Reference: Response to Peer Review Comments

Application for Site Plan Review, Case #8-20

140 Tihonet Road PV+ES Project

Wareham, Massachusetts B+T Project No. 1833.112

**GRAVEL ACCESS ROAD**

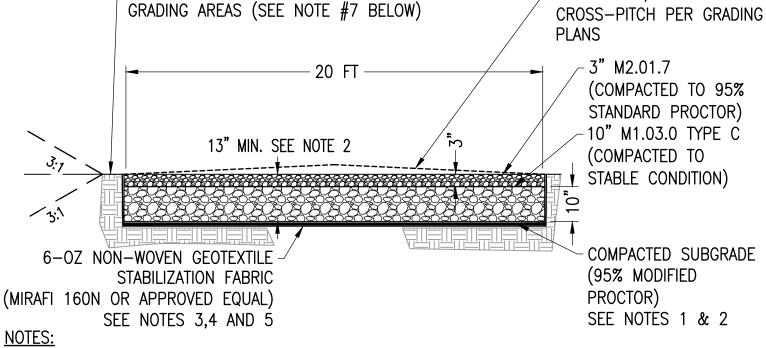
- Solar panels have been removed from Basin 6
- Clearer access has been provided to Basin 1
- Notes were clarified regarding loaming and seeding
- Recommended construction sequence notes have been added

6. SEE NOTE #4 ON SHEETS C-3.1, 3.2, 4.1, 4.2, 4.5, AND NOTE #3 ON SHEET C-2.0

REGARDING LOAMING AND SEEDING OF SITE.
